## CITY OF COCONUT CREEK

### DEVELOPMENT REVIEW COMMITTEE (DRC) REVIEW #1 – JANUARY 7, 2025

| <b>PROJECT NAME:</b>                           | Utilities and Engineering Standards Manual Review          |  |                |
| <b>REVIEW/APPLICATION:</b>                     | Manual Review  |  |                |

## E. Multiuse Paths Requirements

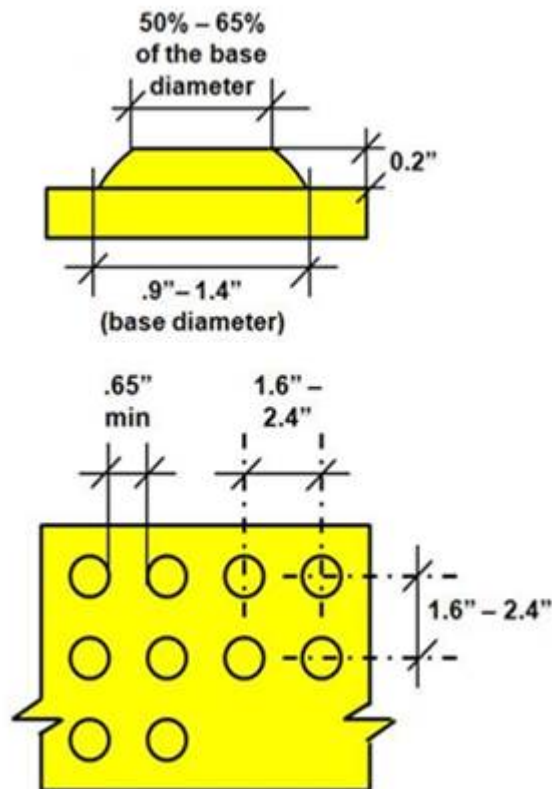
1. Multiuse paths **are recommended to be** a minimum of 10 feet wide with a 1-inch thick asphaltic concrete surface course. **An 8-foot wide shared use pathway shall be reviewed and approved by the City Engineer and/or their designee. Appropriate pavement marking and signage shall be included in the design of multiuse pathway facilities.**
